Technical Upgrades in A²SI Revision C

Figure 1: Package Marking

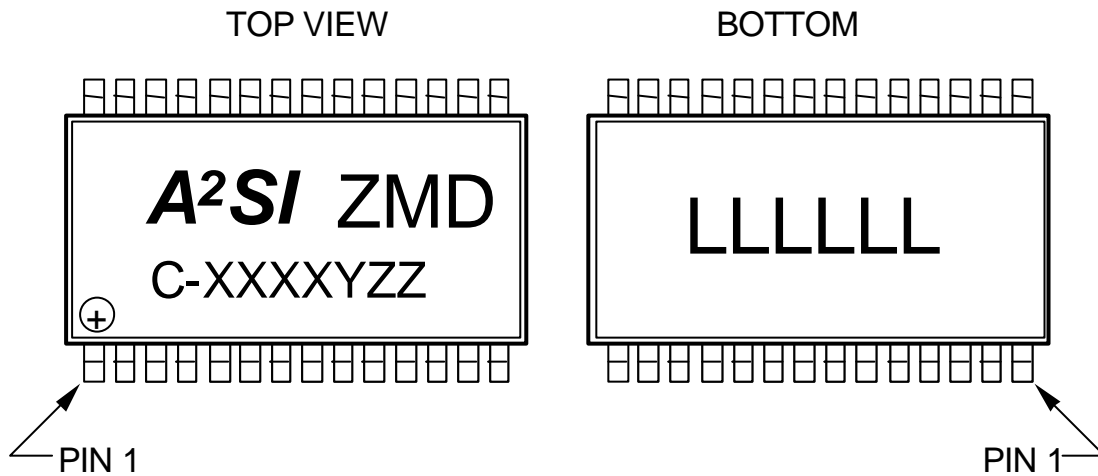
Top Marking: A²SI   Product name
ZMD   Manufacturer
C-   **Revision code marking of A²SI Revision C**
XXXX   Date code (year and week)
Y   Assembly location
ZZ   Traceability

Note: IC Revision A did not have a revision code marking. ICs without a Revision Code are equivalent to Revision A. Revision B shows "B-" .
